REQUEST FOR BIDDING INTERPRETATION (RFBI)

TSS RFBI No.: **43**

Project No.: **3540SRAEU00182**

Project Name: **Parkfield Fire Station Facility Replacement**

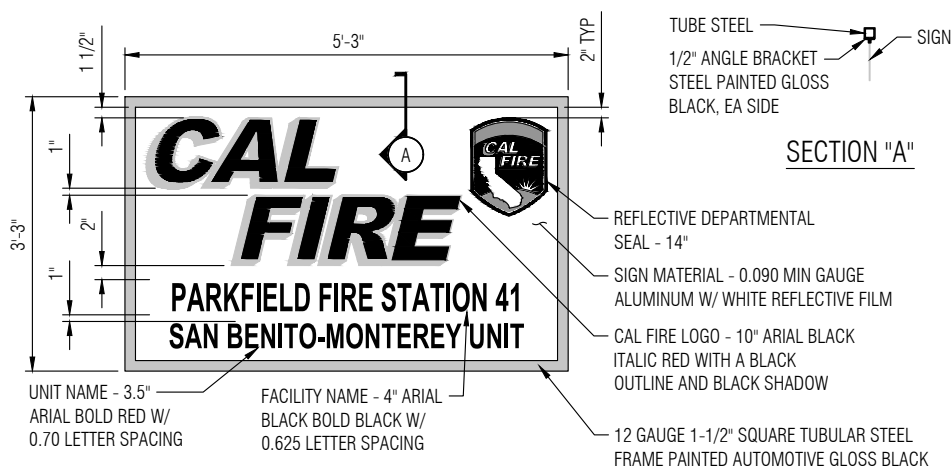
Spec Section 101419 requires a professional engineer to design the sign structure and anchorage of the dimensional character sign, assuming this refers to the sign seen in 1/CS502, please clarify if the delegated design is to include the design of all scope seen in this detail (concrete, masonry, steel numbers, anchorage, rebar, etc.) or just the sign which is shown as a faint grey dotted line or is that sign to be OFOI/OFCI?

Delegated-design requirements in Sections 101419 and 101423 are waived and will be removed by future bid addendum. Construct per detail 1/CS502. The sign is to be included in the contract. Detail below will be added by future bid addendum. - Response by G. Vincent
